REMARKS

Serial No. 09/629,569
Reply to Office Action of 11/24/03

DOCKET: ENS-015-PAP
Date: February 24, 2004

FIGURE 3

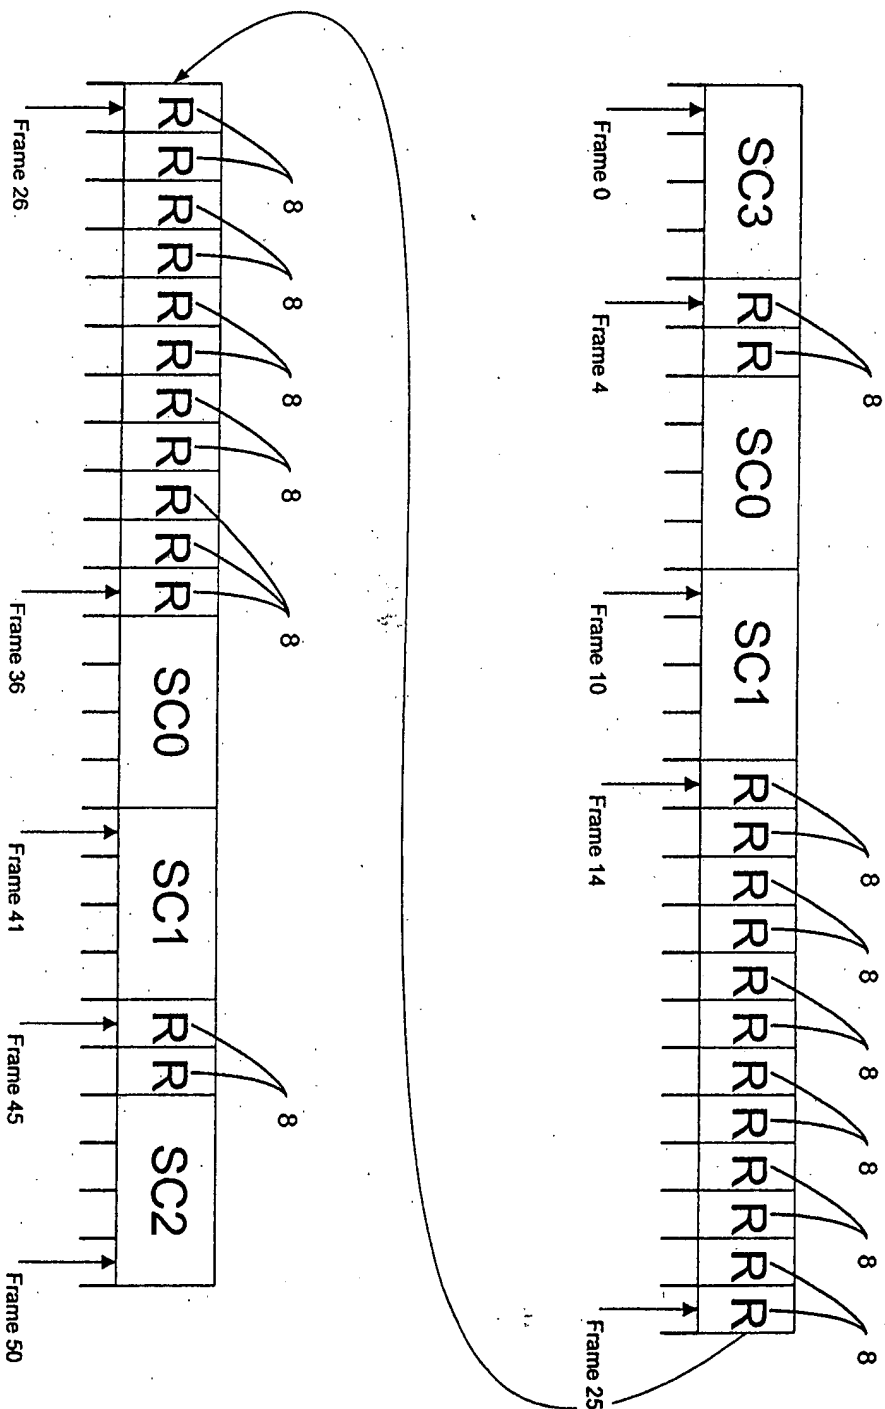
In section 1 of the current Office Action, the Examiner objects to FIGURES 1-3 for failing to indicate that they are prior art. Accordingly, attached hereto are two drawing sheets showing proposed changes to FIGURES 1-3 in red, together with two replacement drawing sheets.

(PRIOR ART)
